Addendum 02 for RFB 943600-01

Project Name: Terrace Hill Elevator Replacement
DAS RFB #: 943600-01
DAS Project #: 9436.00
Date: 1/30/2025

State of Iowa
Terrace Hills Elevator Replacement
Addendum #2
01/29/2025

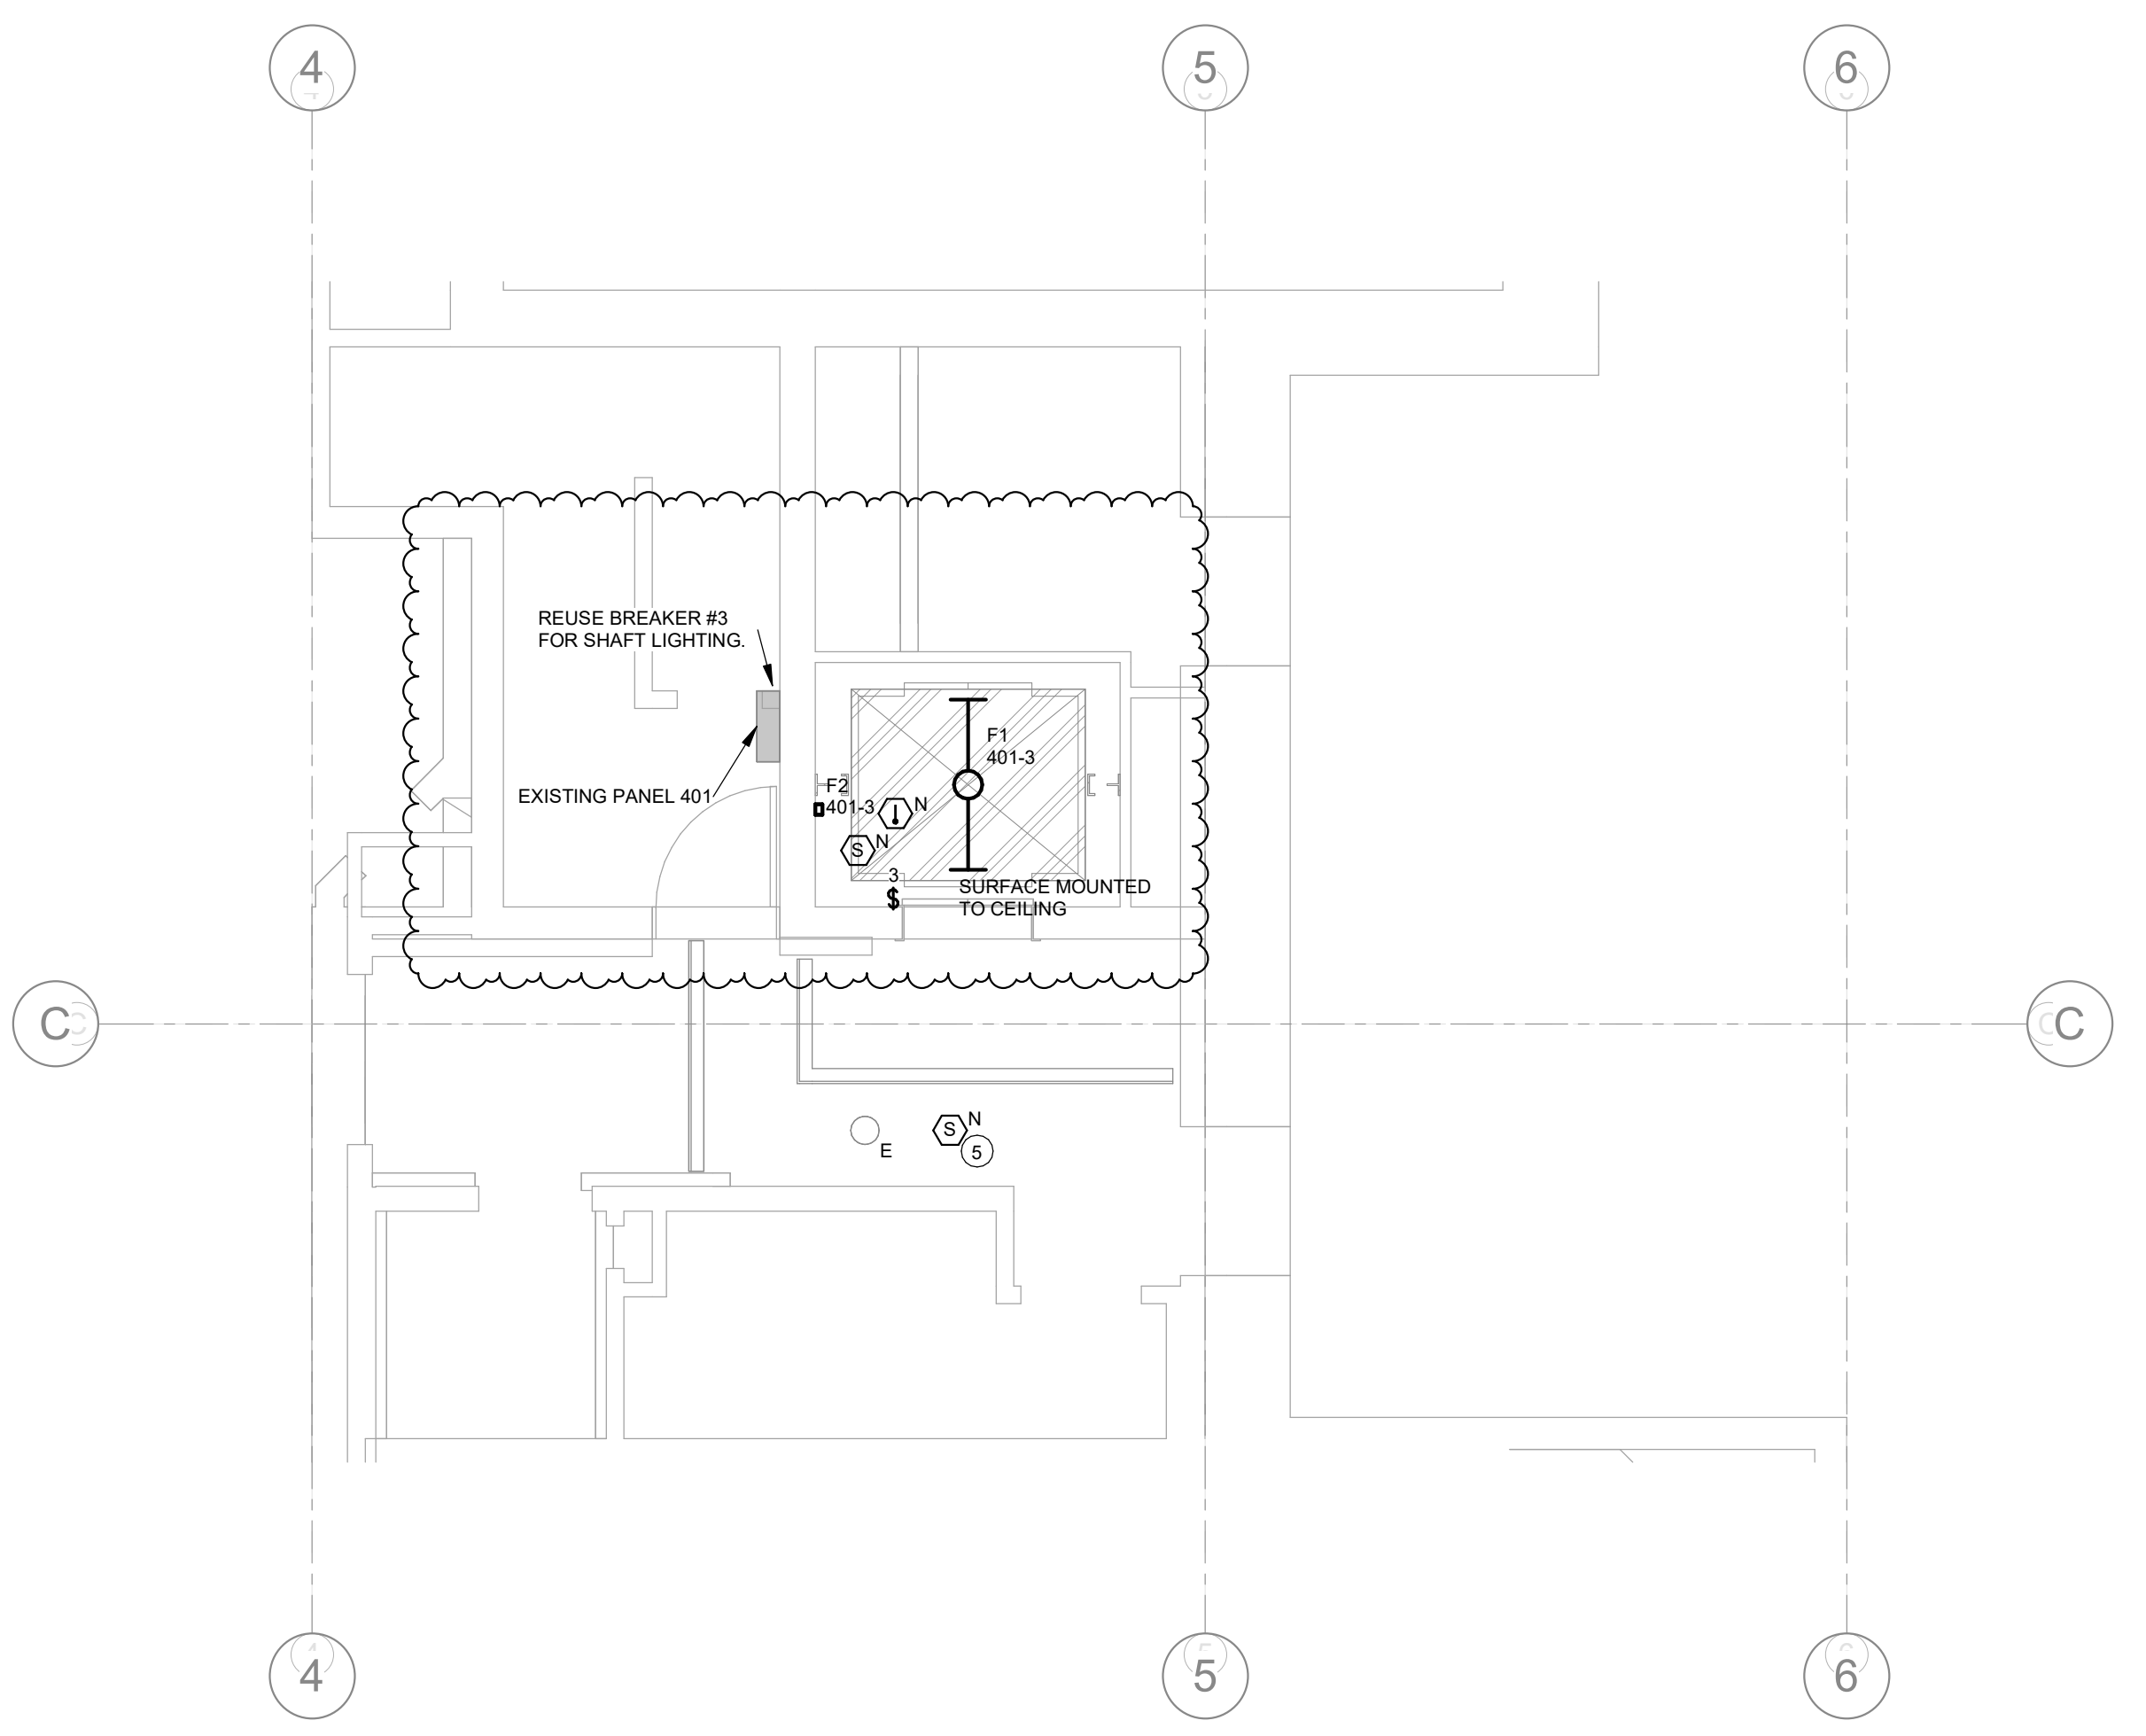
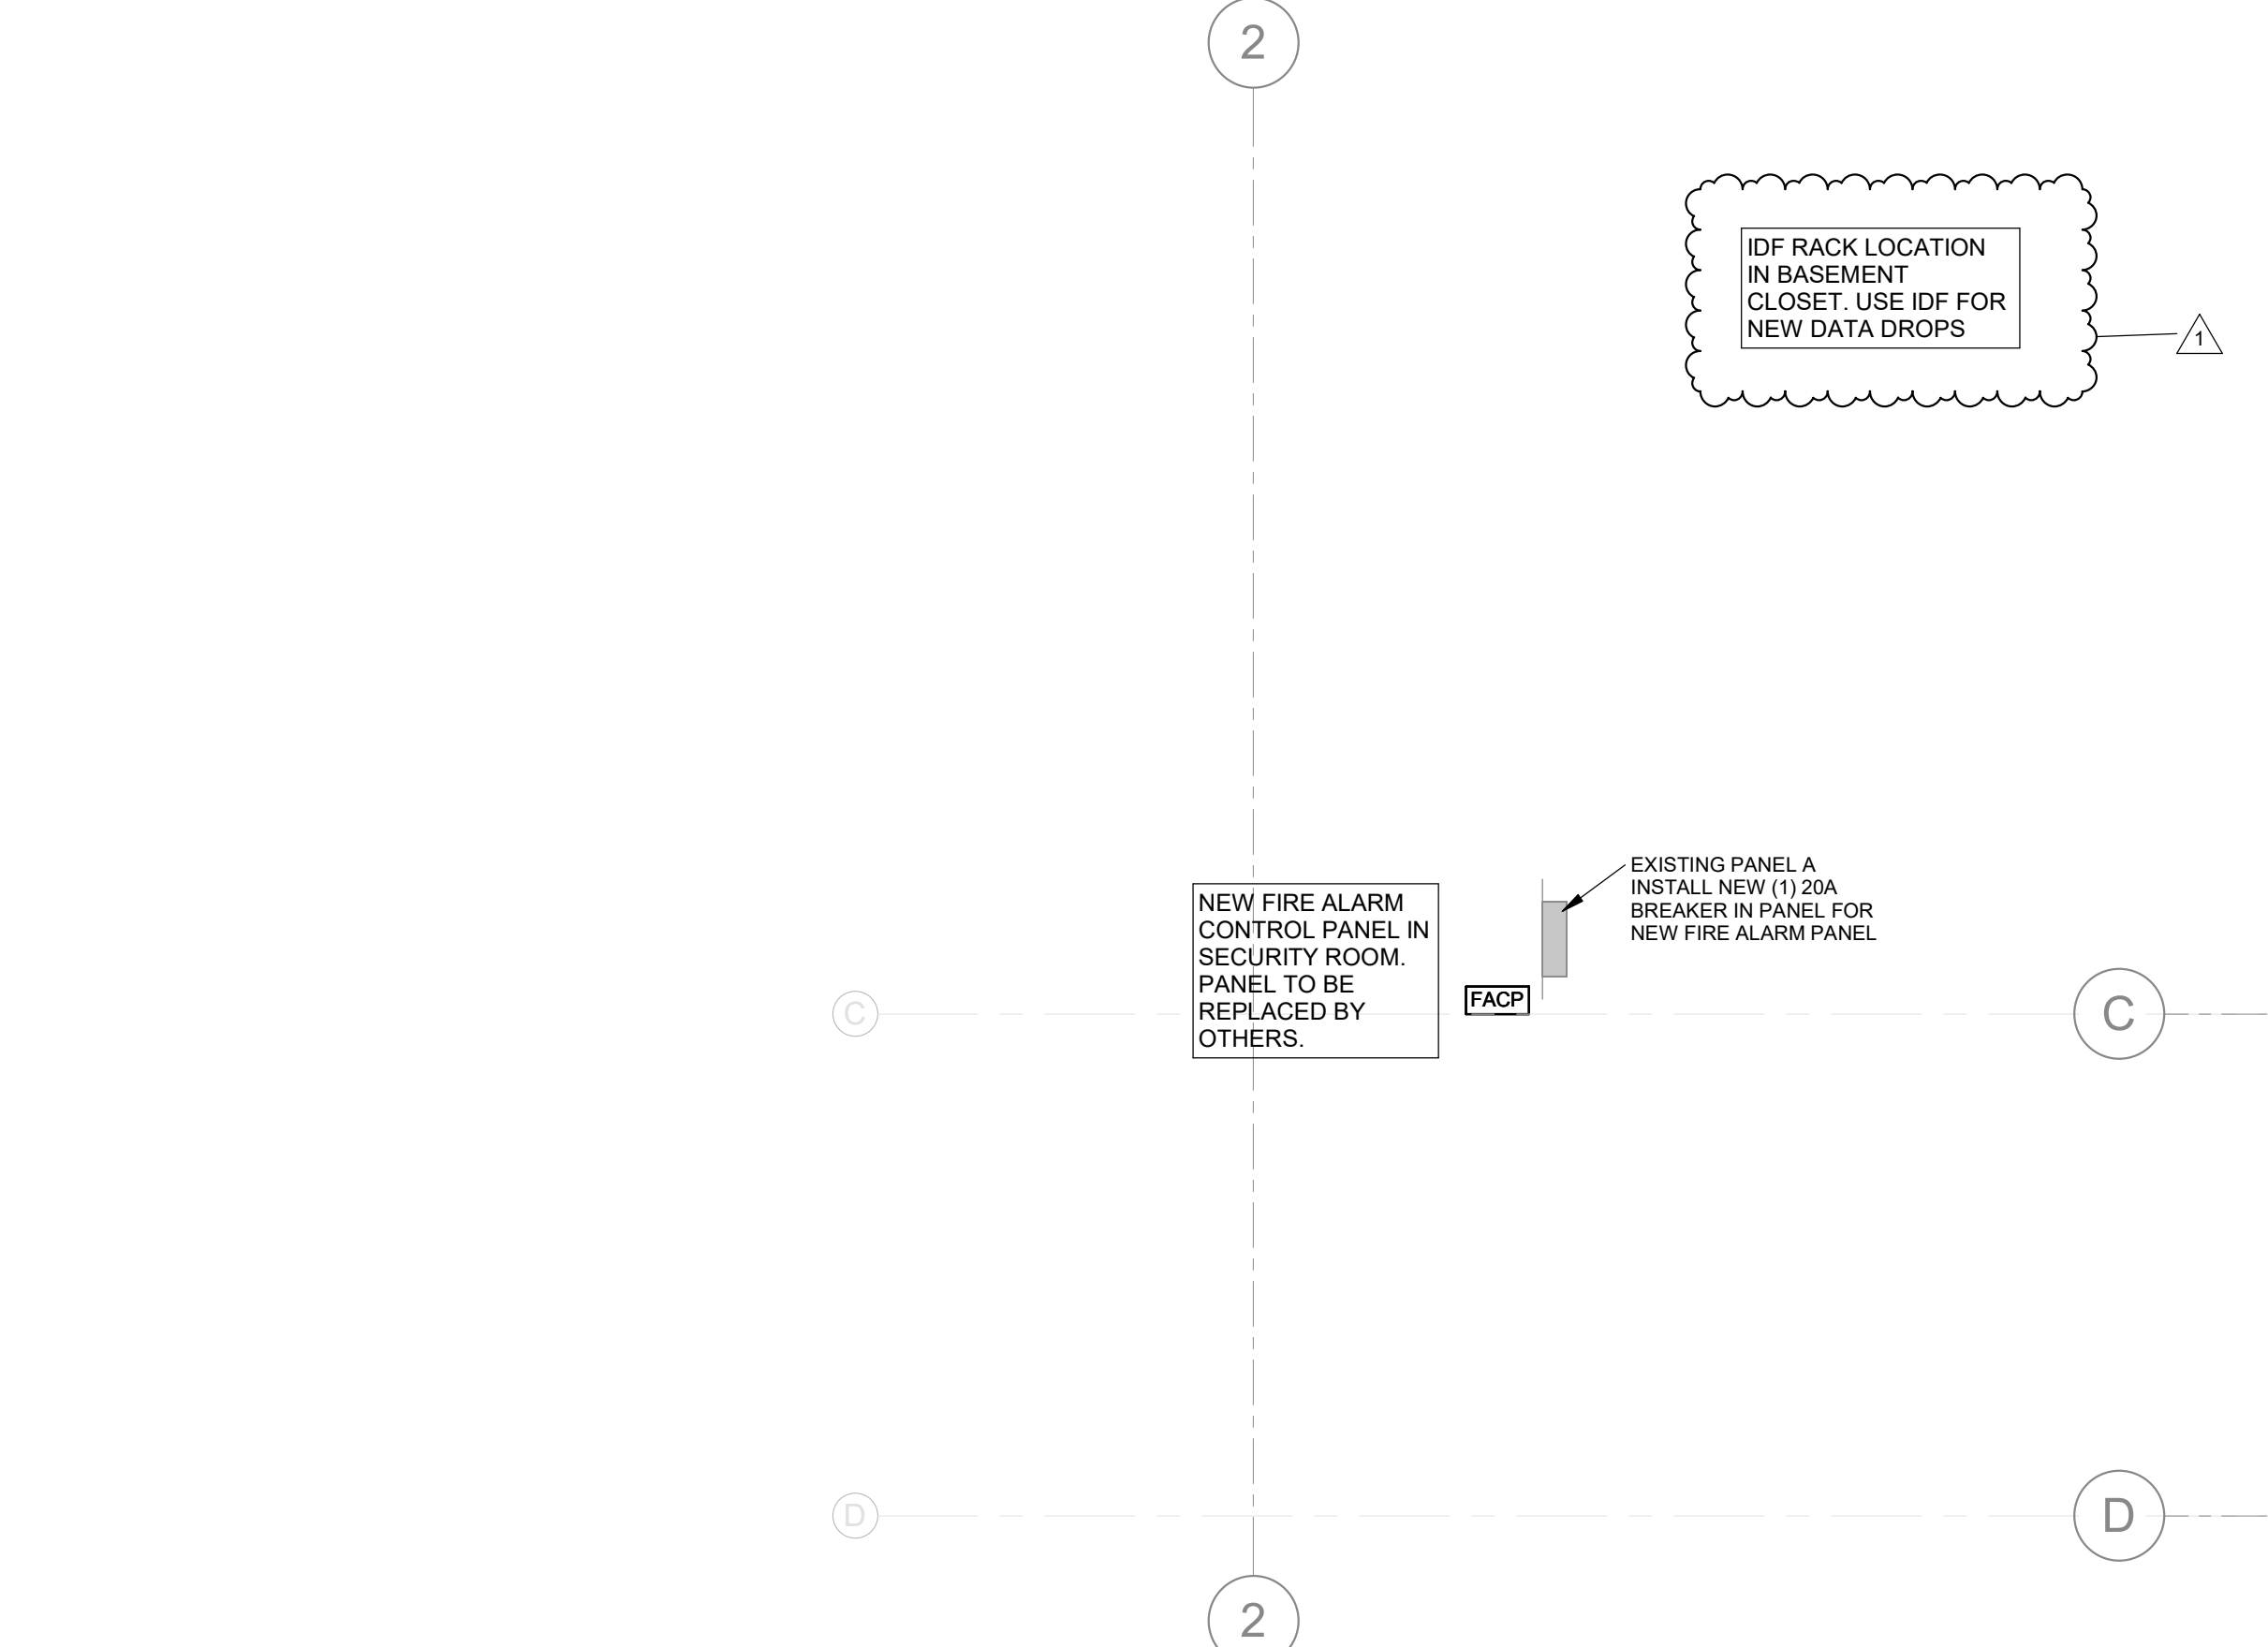
1. Drawing E101 – ELECTRICAL SHEET
 - a. CLARIFY IDF location in basement for installation of the new data cabling.
 - b. REVISE circuit for the lighting in the elevator shaft to the attic panelboard 401.
 - c. REMOVE additional card reader in the elevator cab. Only (1) card access location will be required located on the main elevator control panel.
 - d. Refer to attached full size sheet E101.
